DE10-024 Page 1 of 3

Subject: Re: DE 10-024 Solar Hot Water Heating Incentive Program

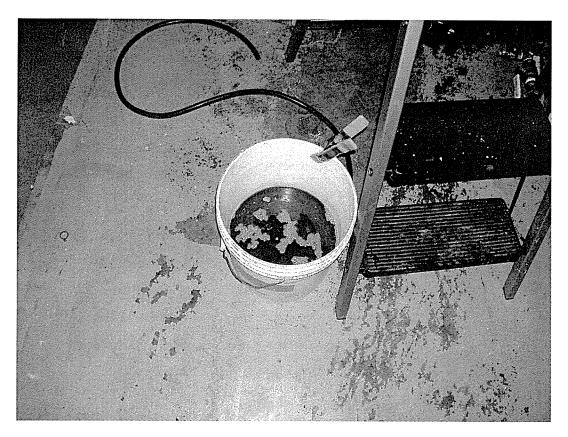
- 1) PVWatts is designed to provide rough numbers for electric generation, not thermal output. This is not relevant to a solar hot water rebate form.
- 2) The incremental incentive for SRCC C-sunny rated system output (10-19MMBTU, 20-29 MMBTU, and 30+ MMBTU). It seems like this could be an incentive to over design a collector- i.e. throw another collector on for good measure (and the extra couple hundred \$), when it may in reality just end up burning the heat transfer medium:

Photo below from a system I serviced: baked proplyene glycol, taken from a large thermal array that was not "dumping" heat as it should have been in summer.

Would it be easier just to set the rebate at a static \$750?
